802.3da Power Bus Simplification

Proposal to remove 802.3da Objective 10

Jason Potterf

2023-06-14

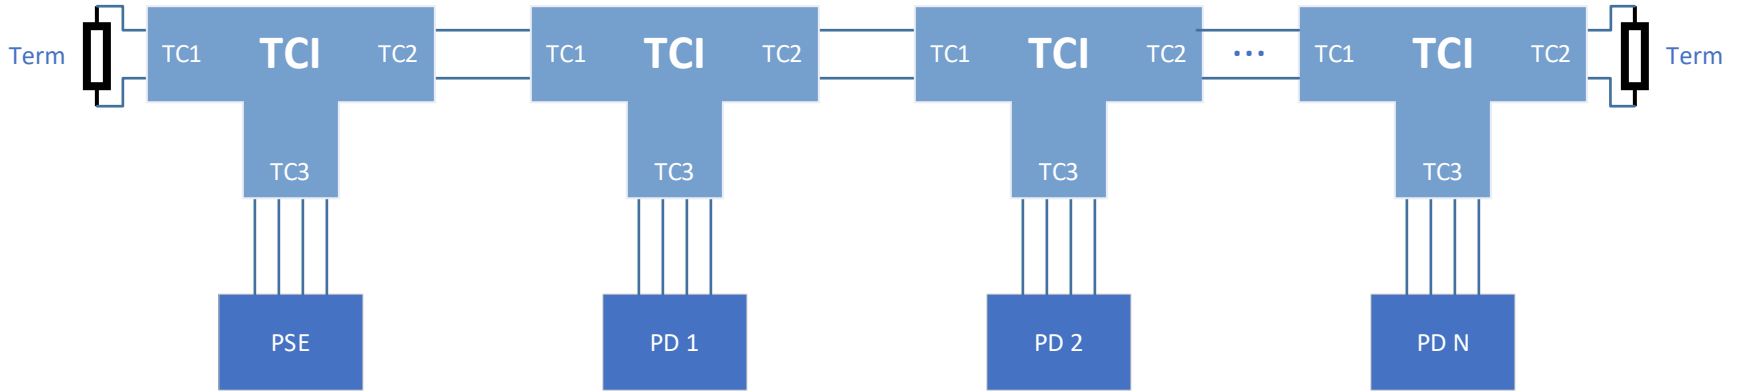
- Now suggesting the following objective change:

~~Objective 10. PSE shall only energize the mixing segment when at least one PD is connected~~

Objective 11. Support addition and removal of a node or set of nodes to a continuously operating powered mixing segment

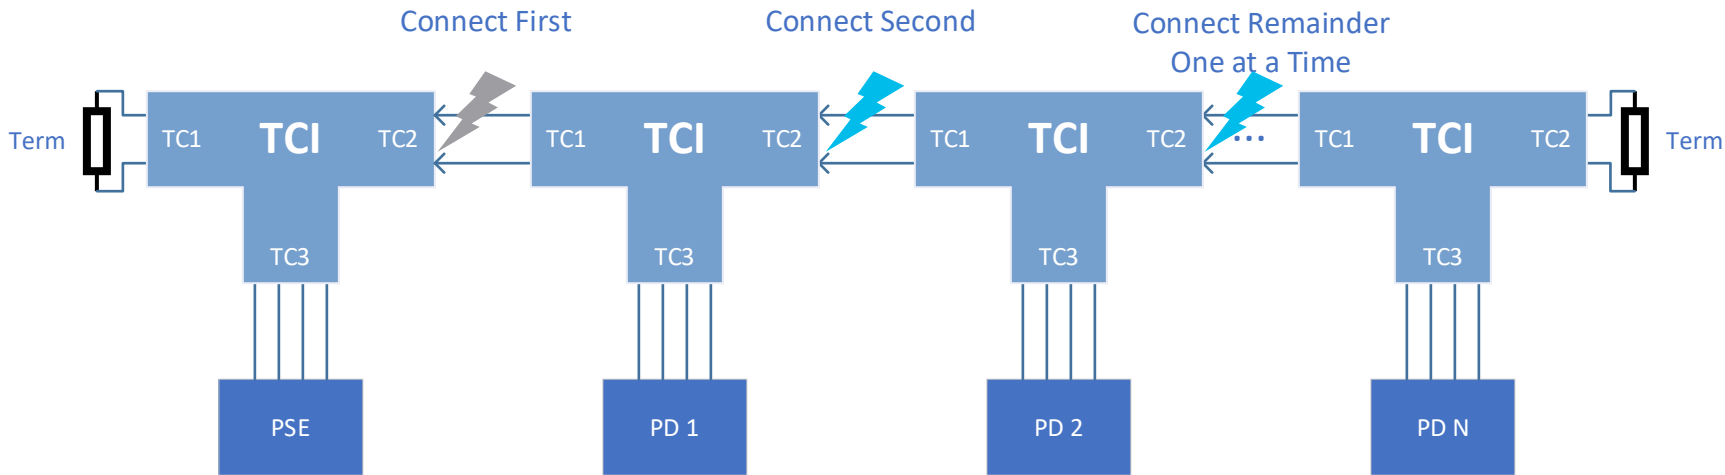
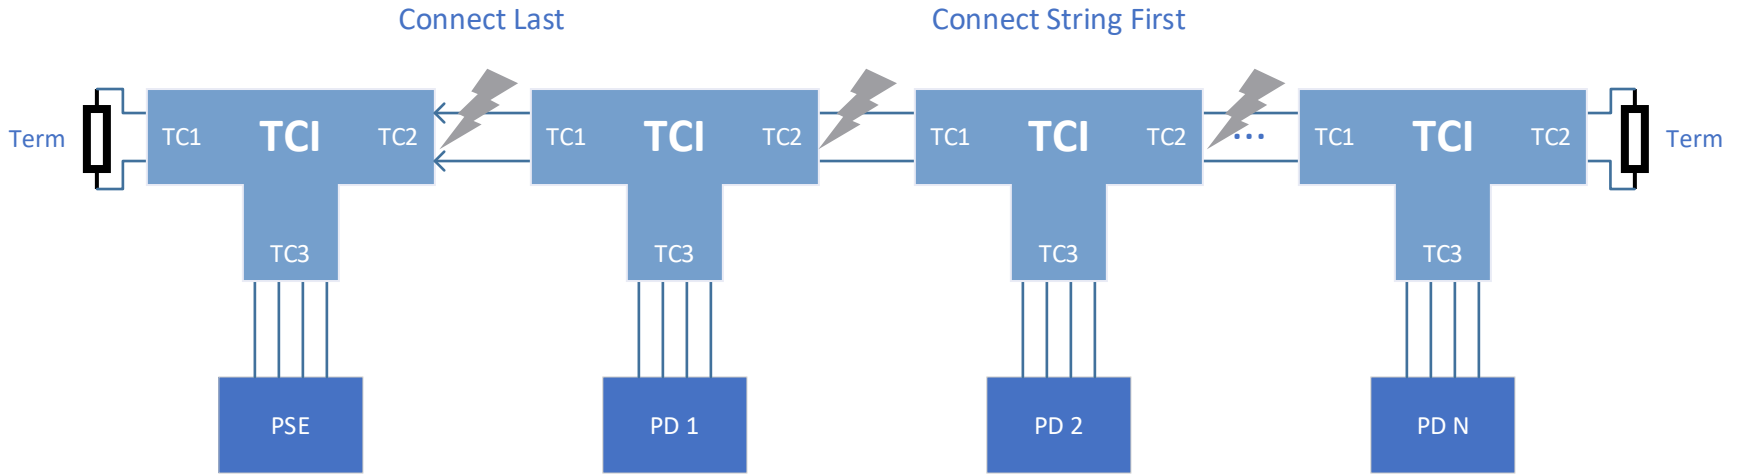
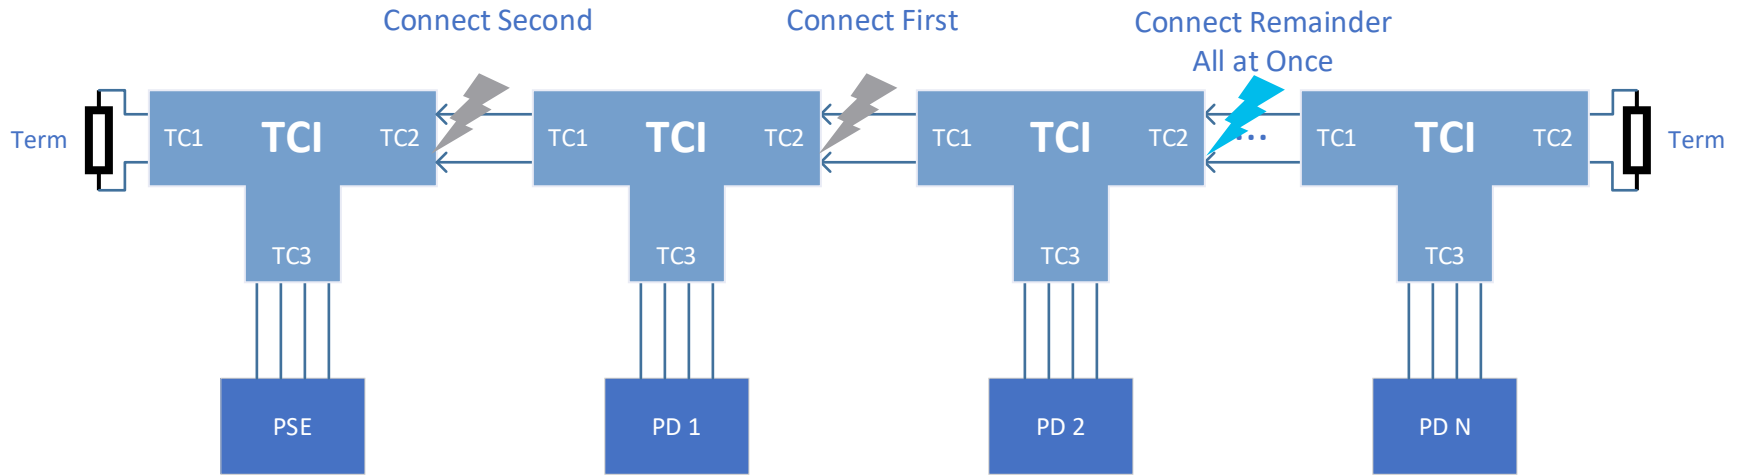
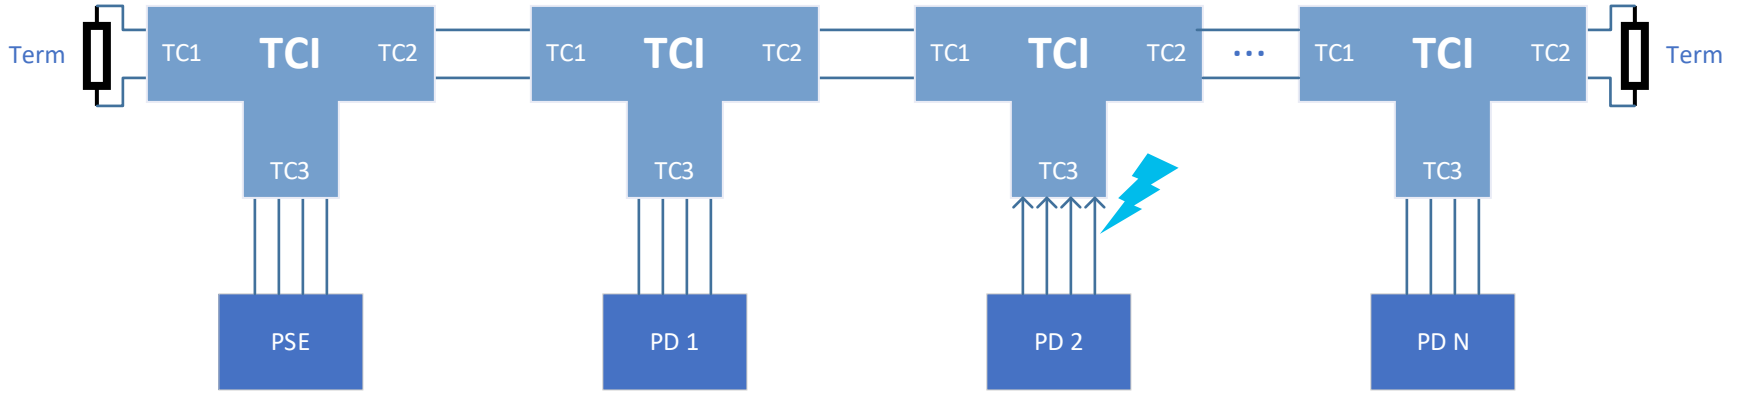
- Objective 10 asks us to only energize the mixing segment when at least one node is present
 - This was intended to prevent energized terminals from being exposed
- Well meaning, but doesn't solve a real problem
- Let's review the connection scenarios **with** Objective 10, but this time identifying the energized terminals with this symbol  and deenergized terminals with 
 - Note: Icons are used to indicate state of terminals at the time of physical connection

Other outcomes exist when PDs are replaced at TC3

- State of terminal energization is difficult to predict
- Detecting and turning on when the first group of any size (1, 2, ... N nodes) is attached only addresses a minority of topology changes
- All other topology changes result in exposed terminals and no detection is performed

Proposal – Drop Objective 10 Entirely

- Consistency and predictability of system behavior is more valuable than additional safeguards on a fraction of topology change cases
- Results in lower PSE implementation complexity
 - PSE enforces current limits only
- Results in roughly the same PD implementation complexity
 - No detection signature required (minor)
 - Inrush limiting required to avoid disrupting the operating powered segment, but this is required even with Objective 10
